Project	IEEE 802.16 Broadband Wireless Access Working Group < http://ieee802.org/16 >	
Title	Corrections and clarifications to OFDMA LDPC Coding	
Date Submitted	2005-06-08	
Source(s)	Robert Xu, Liujun Hu ZTE Inc. 5/F, Bldg.702, Pengji Industrial Park, Liantang, Shenzhen, 518004	Voice: +86 755 26773000 6574 Fax: +86 755 26773000 6616 mailto: xu.jun2@zte.com.cn hu.liujun@zte.com.cn
Re:	Response to Sponsor Ballot on IEEE802.16e/D8 document	
Abstract	In this contribution, we suggest that some text description should be modified to make the matrix be uniform with the text description.	
Purpose	To incorporate the text changes proposed in this contribution into the 802.16e/D8 draft.	
Notice	This document has been prepared to assist IEEE 802.16. It is offered as a basis for discussion and is not binding on the contributing individual(s) or organization(s). The material in this document is subject to change in form and content after further study. The contributor(s) reserve(s) the right to add, amend or withdraw material contained herein.

Corrections and clarifications to OFDMA LDPC Coding

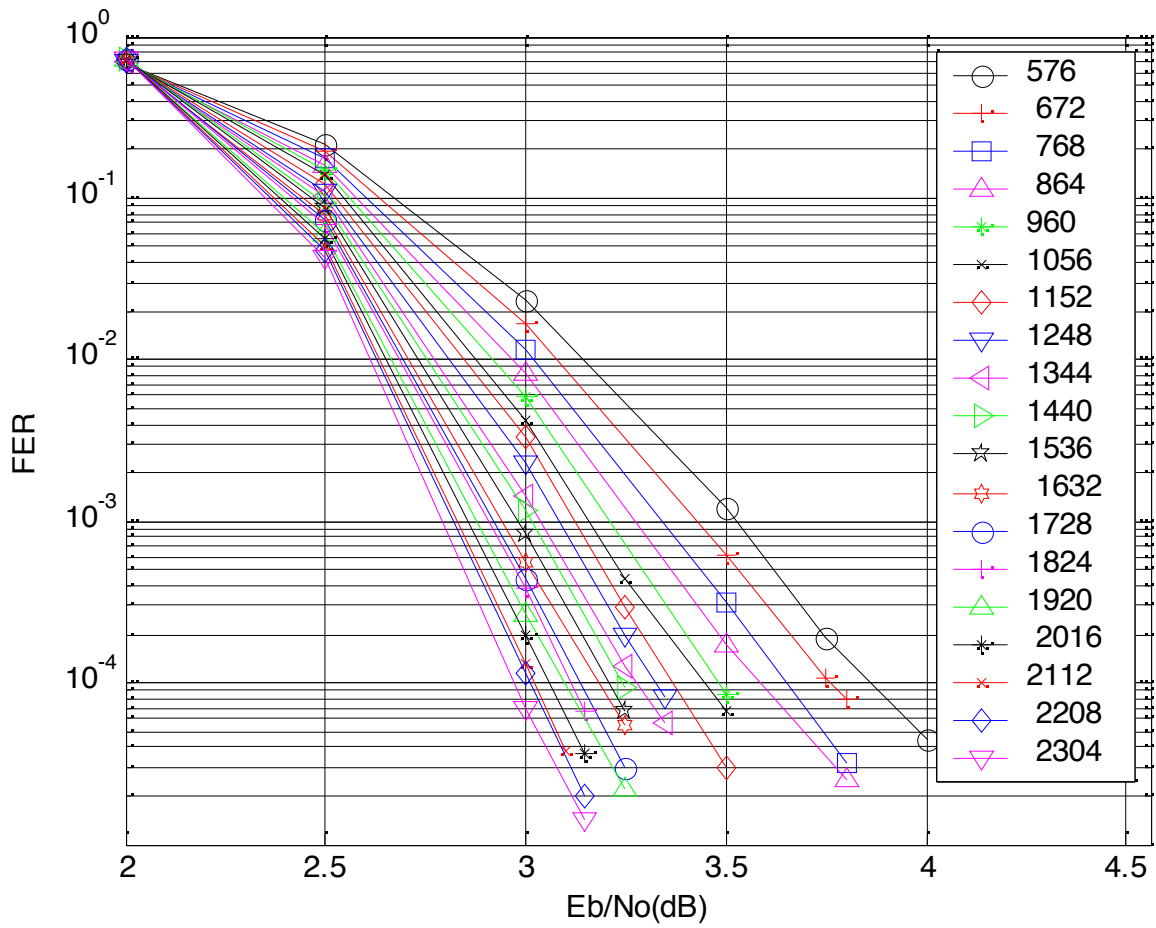
However, in order to get better uniform form about LDPC base model matrices, we suggest that the base model matrix of rate 3/4 codes should be changed from “0-a-0” encoding structure to “a-0-a” encoding structure. Through careful selection and simulation, we can ensure that the text change will not affect the performance of original rate 3/4 B codes.

Simulation results for the rate 3/4 code B families are shown in Figure 1. For the rate, code sizes considered are all 576-2304. The simulation conditions are: AWGN channel, BPSK modulation, max iterations times 50, using generic floating-point belief propagation. From the simulation results we can find that our codes overcome the “error floor” phenomenon, and the BER curve of them will descend more steeply. When SNR is high, our high girth method obviously obtained an improved performance.

The expansion factor z ranges from 24 to 96, as shown in Figures 1. The block size and the expansion factor are related by $n = 24 * z$.
